**DEFENSE NUCLEAR FACILITIES
SAFETY BOARD**

August 11, 2022

Staff Report

Los Alamos National Laboratory Plutonium Facility Updated Leak Path Factor Analysis

Figure 1. Leak path factor methodology and software packages

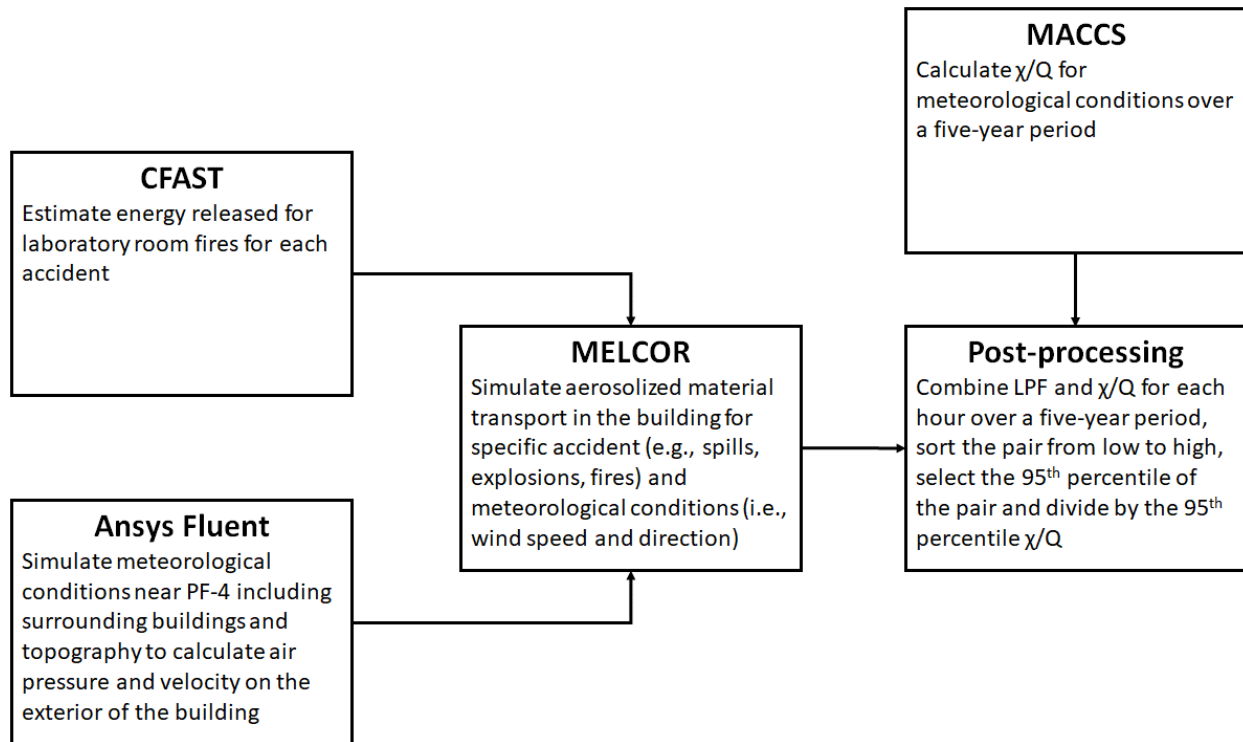
Based on the working papers and on discussions with Triad, the Board's staff found that the updated LPF methodology will have similar issues to the existing LPF methodology but will use different or updated software packages. The LPF methodology and software packages are described in Figure 1. Triad plans to use MELCOR version 2.2, which is newer than the version listed in the DOE Safety Software Central Registry¹ (version 1.8.5); Ansys Fluent release 19.0 (a

non- “toolbox” code); and CFAST version 7.1.1 (a “toolbox” code). For all safety software used, including software listed in the central registry, Triad personnel must ensure that the versions used meet software quality assurance requirements. The staff understands that Triad plans to provide supporting software quality assurance documentation for the code versions used in the final calculations.
